Process Change Notification

PCN Number: PCN-2021-147

WM8940 Material Part Marking Format Standardization

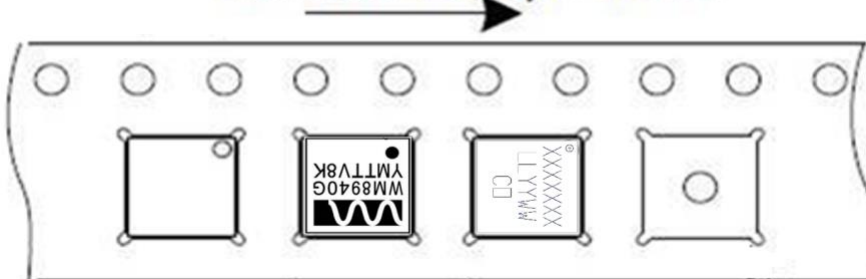
- Marking Format:** Consistent with Cirrus Logic Mark Format Standard

From	To	
Wolfson Marking Format 	Cirrus Logic Format 	Line 1: Part Number (7 characters maximum) Line 2: Package Mark (6 characters maximum) Line 3: Country of Origin (2 characters as shown on PO) LL = Lot Sequence Code YY = Year of Manufacture WW = Work Week of Manufacture

Special Note: The Pin 1 orientation does not change in the Tape-N-Reel
